BID # MCC19-01

ADDENDUM NUMBER 02

MCC Lab Renovations

At Manchester Community College

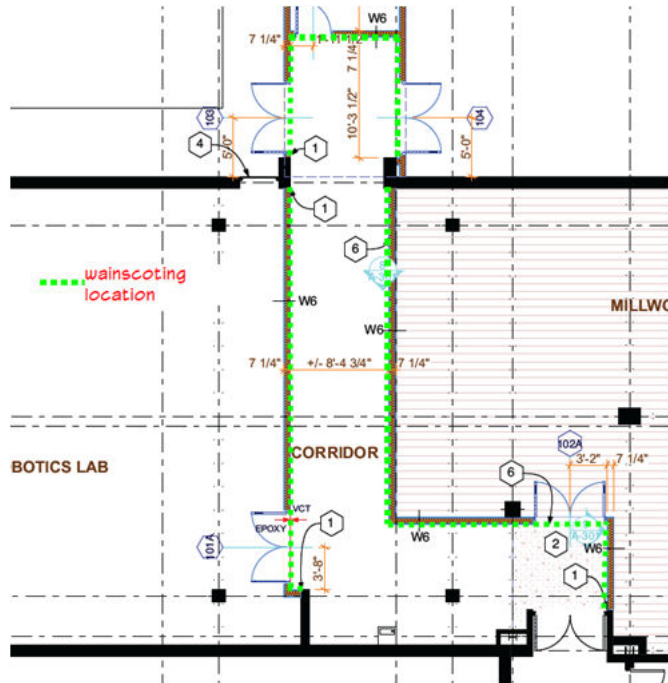
QUESTION #7: In the electrical lab there is a mock-up of typical construction of generator, solar, and wind power on a wood frame structure. Should we anticipate this to be in this space for construction? Will the platform be able to support a scissor lift? Should we anticipate an articulating boom lift?

The mock-up of typical construction of generator, solar, and wind power on a wood frame structure will remain. I doubt if the platform could support a scissor lift.
